November 29, 2018

**RE: 53480 Bridal Falls Road – Bridal Falls RV Cottage Resort**

July 24, 2018

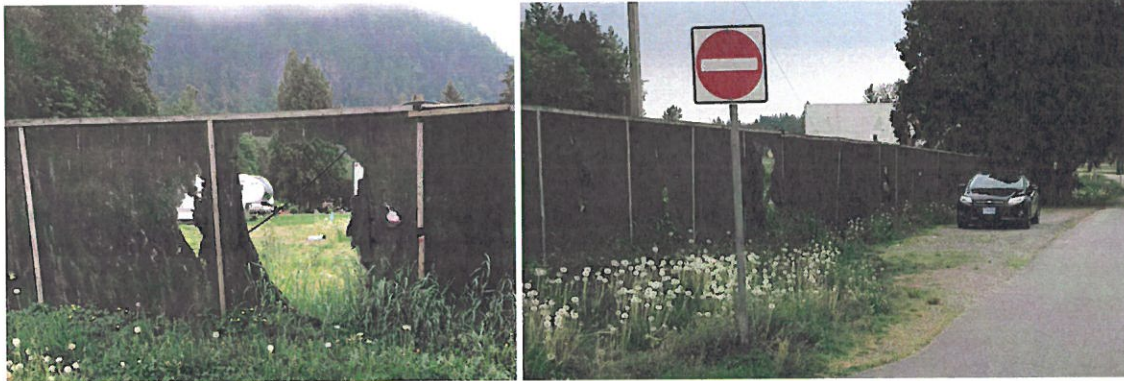
1. In accordance with registered covenant CA4044029 fencing must be installed on the top of all retaining walls in excess of 1.20m as detailed on the Fencing/Retaining Wall Plan prepared by Civic Consultants Ltd. and dated July 28, 2014, a copy of which is attached hereto. You advised that this will be completed with the completion of each phase of development, and this is acceptable to the FVRD.

Fencing is required throughout the development on all walls over 1.2m
